PHED COMMITTEE #1
February 29, 2016

TO: Planning, Housing, and Economic Development (PHED) Committee
FROM: Glenn Orlin, Deputy Council Administrator
SUBJECT: Westbard Sector Plan—evaluation of public school and transportation adequacy at buildout; transportation elements

BENEFITS ANALYSIS

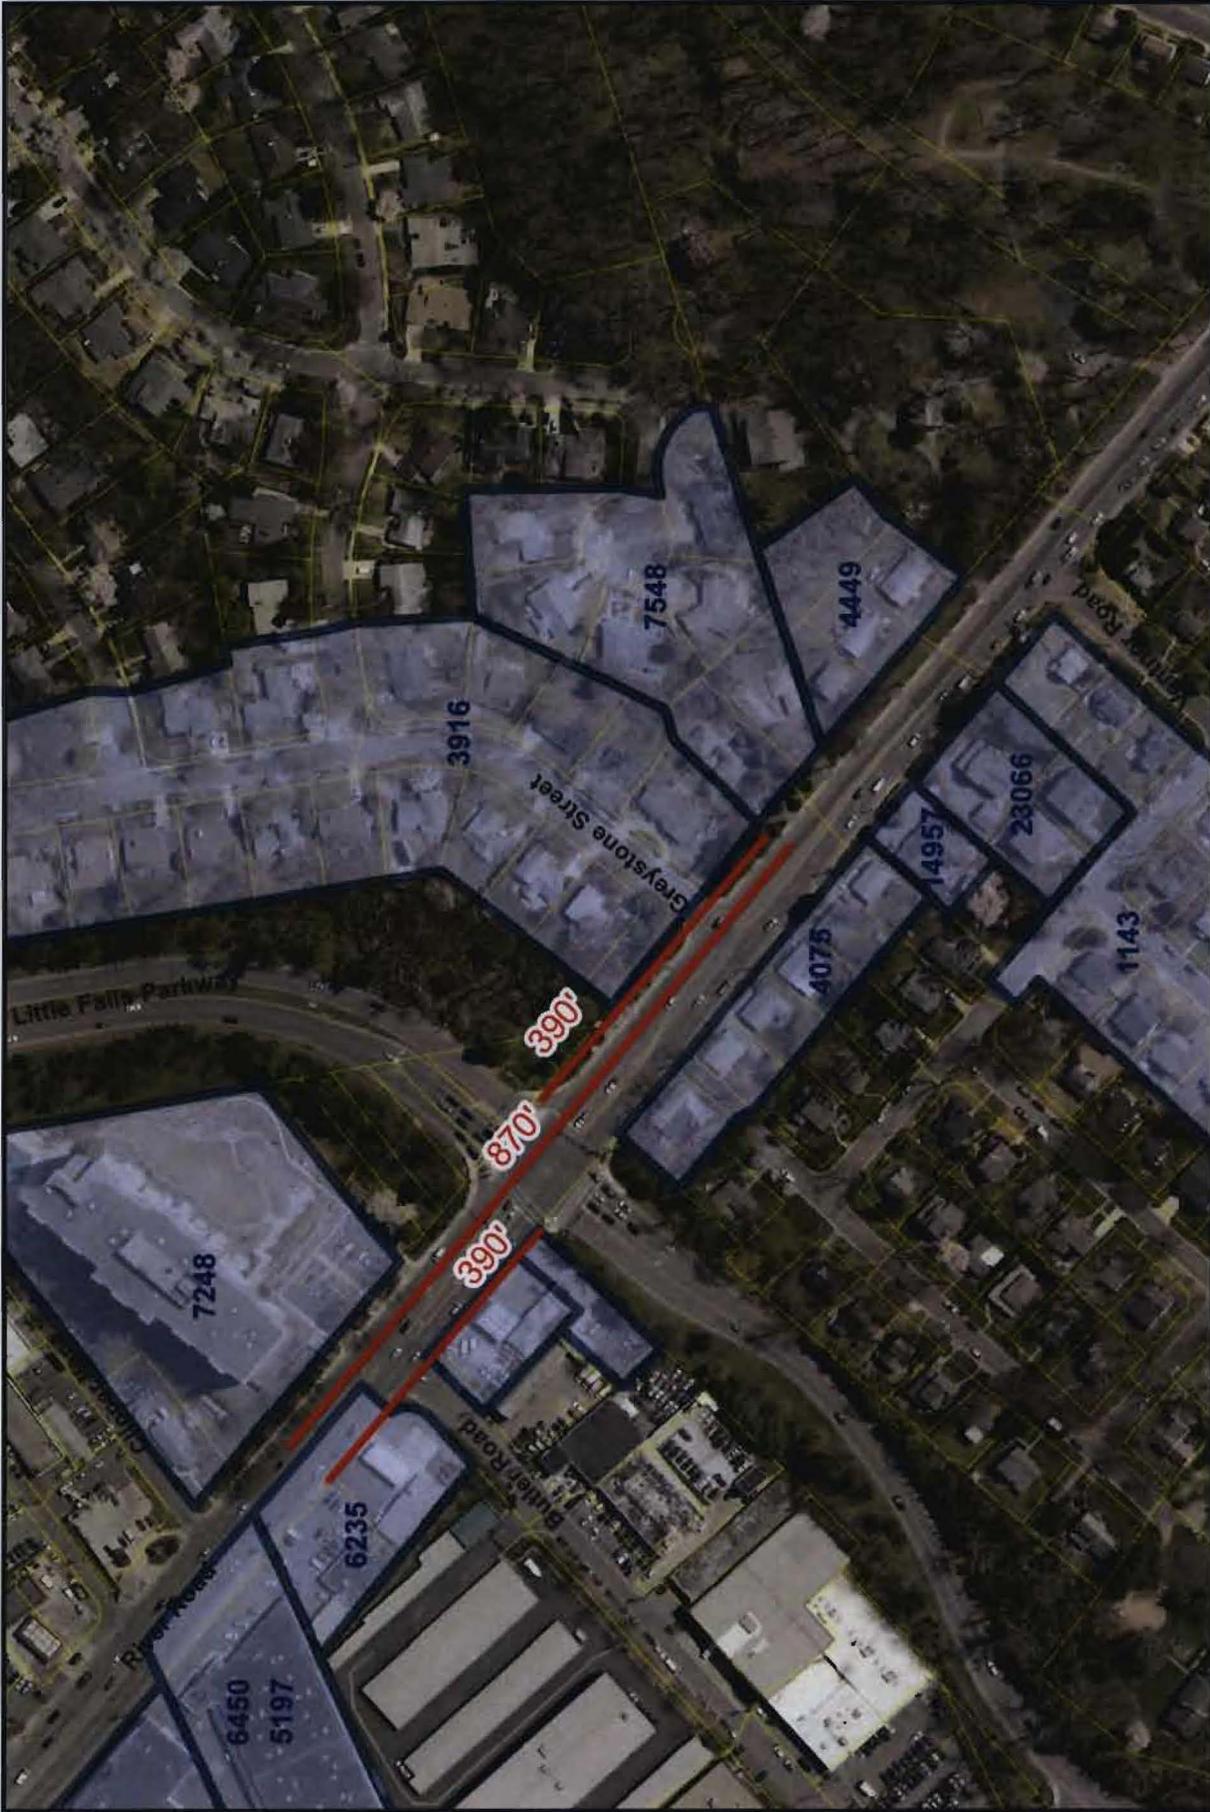
In its current configuration, the River Road (MD 190) right-of-way is approximately 90-feet wide on the west side of Little Falls Parkway and 100-feet wide on the east side of Little Falls Parkway. The current Planning Board Draft Sector Plan recommends that the future right-of-way be a minimum of 110-feet wide. Generally speaking, an additional northwest bound through-lane could be accommodated within the existing right-of-way and existing curb-to-curb pavement section, however, lane widths would need to be reduced to a width of 11 feet. This lane reduction is also consistent with the intent of the draft sector plan's recommendation to designate Westbard an Urban Road Code Area (see Sec. 49-32(g): Lane Width).

For the purposes of this analysis, staff assumed that implementation of the additional through-lane would require a total distance of approximately 870 linear feet, extending 435 linear feet in each direction from the center of the intersection (390 linear feet from the stop bar). This configuration would carry the additional through-lane just beyond the adjacent intersecting streets on either side of the River Road/ Little Falls Parkway intersection and would provide storage for approximately 18

additional vehicles during the red signal phase on River Road¹. To the west of the intersection, the additional through-lane would extend along the entire frontage of 5110 River Road, a "Shell Gasoline Station," and would include within its limits the intersection of River Road and Butler Road. To the east of the intersection, the additional through-lane would extend along the entire frontage of 5401 Greystone Street, a "single family residence," and would include within its limits the intersection of Greystone Street. Further study may deem necessary longer through-lanes.

Council staff recommendation: Either retain the third outbound through lane through the intersection or replace it with just an outbound right-turn lane. The trade-off is between: carrying the cycle track/sidewalk through to the intersection; or having a shared-use path in the last few hundred feet while also providing more congestion relief. In either case there would be land takings within the planned 110'-wide right-of-way, and the construction costs and impacts would be comparable.
